W EMERGENCY CORE COOLING SYSTEM  
EVALUATION MODEL FOR ANALYZING (N-1)

LOOP OPERATION OF PLANTS  
WITH LOOP ISOLATION VALVES

SUBJECT: SAFETY EVALUATION OF WCAP-8904

TOPICAL REPORT EVALUATION

Figure 2 Typical SATAN Model for a PWR Inactive Loop Break (49 Elements)

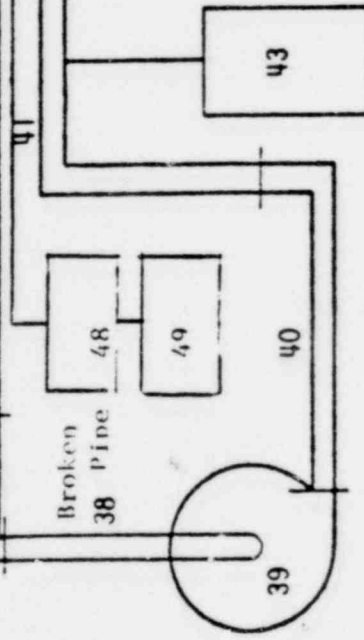
1. Break nodding studies for the Westinghouse LOCA model were reported in WCAP-8341. That study indicated that two nodes on each side of a postulated double ended failure were required. For the proposed (N-1) loop model, the vessel side of inactive loop broken leg is modeled with one node. Justify the use of a single node at that location in view of the study reported in WCAP-8341.

To assess the effect of broken leg nodding on the ECCS performance calculation for the inactive loop break location, the limiting inactive loop break cases for three and four-loop plants reported in WCAP-8904 were reanalyzed. Two nodes of equivalent length were used to model the length of pipe between the reactor vessel inlet and the break in the SATAN code; other input was held constant in order to obtain the sensitivity to break nodalization. Results of the analyses performed are presented in Tables 1 and 2. The peak clad temperature calculated for each case is within a few degrees of the previous result reported in WCAP-8904 (i.e. 1813 and 1748°F respectively for 3 and 4 loop plants), so the active loop break location remains limiting for both 3-loop and 4-loop plants.

Figure 3B Schematic of REFLOOP Code 14 Element Loop Model Inactive Loop Break

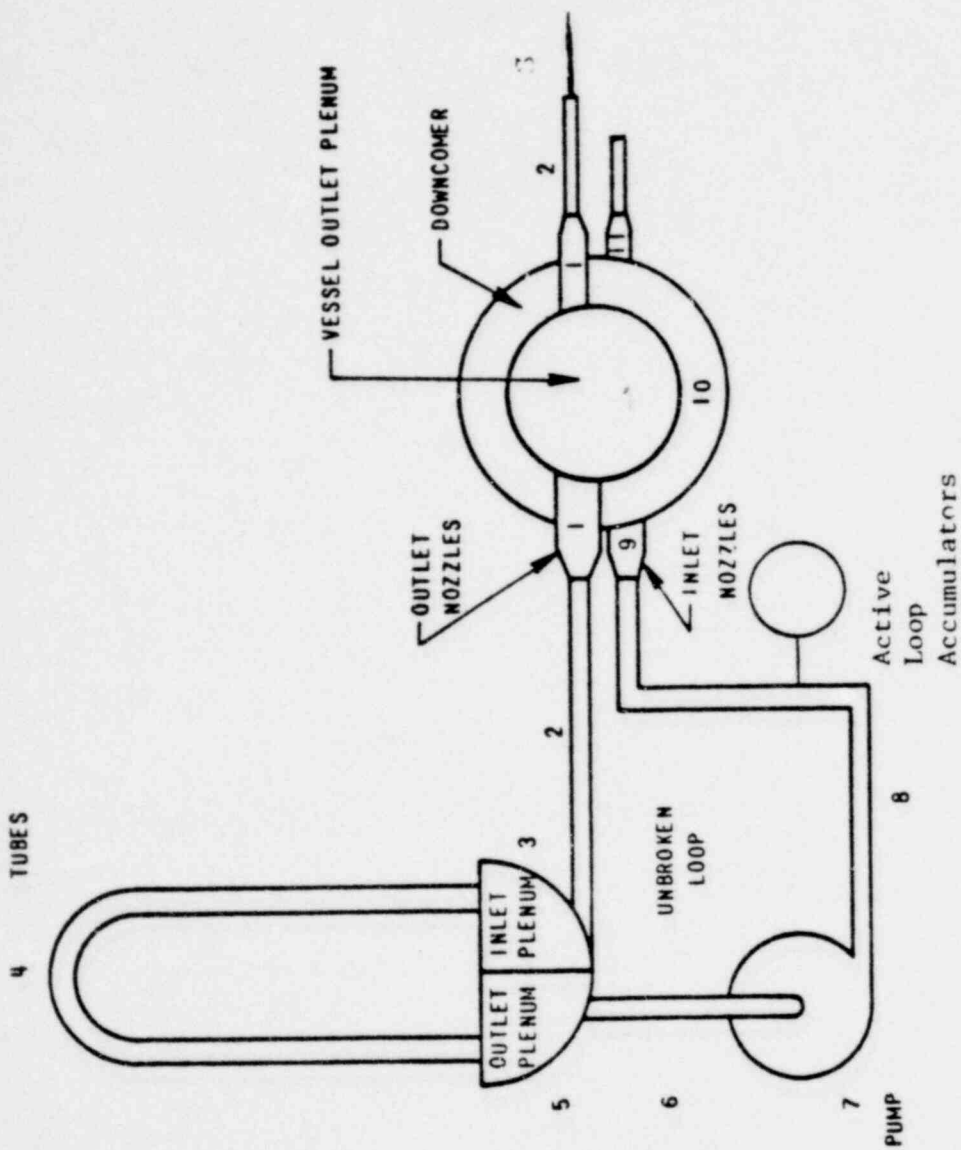
2. Describe in detail why, during reflood, the inactive loop dead-ended pipe was modeled as three nodes with successively lower flow areas and successively higher loss coefficients.

The WREFLOOD code loop model approved as part of the October 1975 version of the Westinghouse Evaluation Model consists of two parallel flow paths which connect the reactor vessel upper plenum with the break: a path through the broken loop and a path through the unbroken loops. For an inactive loop cold leg break during plant operation in the (N-1) configuration, no venting through the broken loop is possible if the loop isolation valves are closed. In order to use the October 1975 Model version of WREFLOOD in this inactive loop break application, it is imperative to set the flow resistance of the broken loop such that no significant flow occurs in the broken loop. Therefore, the inactive loop dead ended hot leg pipe was modeled as three nodes with successively lower flow areas [1, 0.1, 0.01 ft<sup>2</sup>] and successively higher loss coefficients [1, 10, 100].

With this resistance network specified, code execution was achieved with minimal (less than 0.1 lb/sec) flow through the broken loop at all times. The path through the unbroken loops to the break was specified as in the N-loop break case.

Figure 1: 3-Loop Plant (N-1) ECCS Analysis:

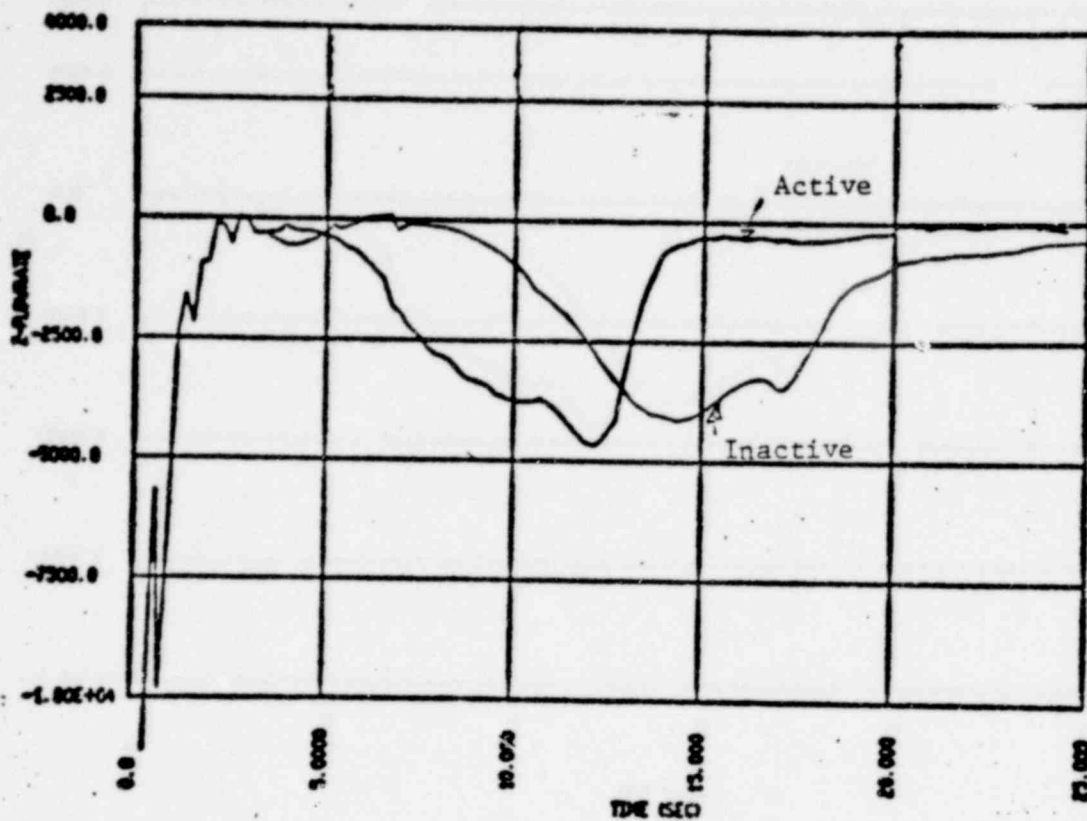
3. Justify for a spectrum of break sizes that the active loop breaks always give higher peak clad temperature.

The spectrum of break sizes presented in WCAP-8904 has been extended to include additional inactive loop break cases based upon the same plant parameters as the corresponding cases reported in WCAP-8904. Inactive loop DECLG breaks during (N-1) loop operation have been analyzed for a 4-loop plant ( $C_D = 1.0$ ,  $C_D = 0.4$ ) and for a 3-loop plant ( $C_D = 0.6$ ). The results are summarized in Tables 1 and 2.

For both 3-loop and 4-loop plants the active loop is confirmed to be the limiting break location, with the  $C_D = 0.4$  DECLG case the limiting break size. It is interesting to note that for the  $C_D = 0.6$  DECLG break in a 3-loop plant the inactive loop break location gives a higher peak clad temperature ( $1771^\circ\text{F}$ ) than does the active loop location ( $1754^\circ\text{F}$ ). A comparison of the core mass flows during blowdown is presented as Figure 1; it reveals a smaller difference exists between the 3-loop plant  $C_D = 0.6$  DECLG active and inactive loop break core flows than has been the case for other break sizes. As a result a smaller relative reduction in PCT is obtained during blowdown for this inactive loop break than for other cases.

The PCT increase resulting from its lower core reflooding transient becomes sufficient to cause the inactive loop break location to exhibit a higher PCT than the active loop break location for a 3-loop plant  $C_D = 0.6$  DECLG LOCA.
